Shop Drawing Submittal Review

Project Name: Webster University-**ISB**

PROJECT NAME: Webster University ISB
LOCATION: St. Louis Missouri
CLIENT PROJ. NO.: N/A
WES PROJ. NO.: 607
SPEC SECTION: 22 1319 Sanitary Waste Piping Specialties
SUBMITTAL ITEM: See Below -

RE: Sanitary Specialties Product Data

Floor Sinks - Square

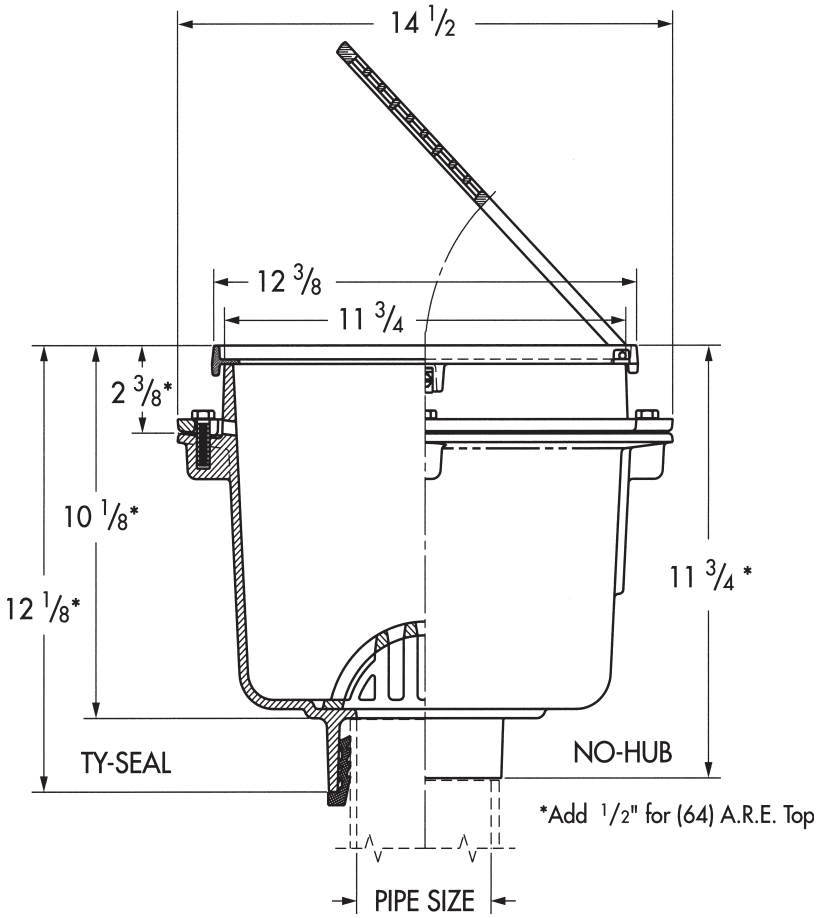
FS-2	FS-2 FLOOR SINK PER ADDENDUM #2-1
W915012NH6152426 WADE 27VP	12” SQUARE, A.R.C. FLOOR SINK, 10” SUMP DEPTH, NICKEL BRONZE - 2" NO HUB, 1/2" TRAP PRIMER CONNECTION, 1/2 GRATE, ANCHOR FLANGE, CLAMPING COLLAR, ALUM SEDIMENT BUCKET, VANDAL PROOF
W915013NH6152426 WADE 27VP	12” SQUARE, A.R.C. FLOOR SINK, 10” SUMP DEPTH, NICKEL BRONZE - 3" NO HUB, 1/2" TRAP PRIMER CONNECTION, 1/2 GRATE, ANCHOR FLANGE, CLAMPING COLLAR, ALUM SEDIMENT BUCKET, VANDAL PROOF
W915014NH6152426 WADE 27VP	12” SQUARE, A.R.C. FLOOR SINK, 10” SUMP DEPTH, NICKEL BRONZE - 4" NO HUB, 1/2" TRAP PRIMER CONNECTION, 1/2 GRATE, ANCHOR FLANGE, CLAMPING COLLAR, ALUM SEDIMENT BUCKET, VANDAL PROOF
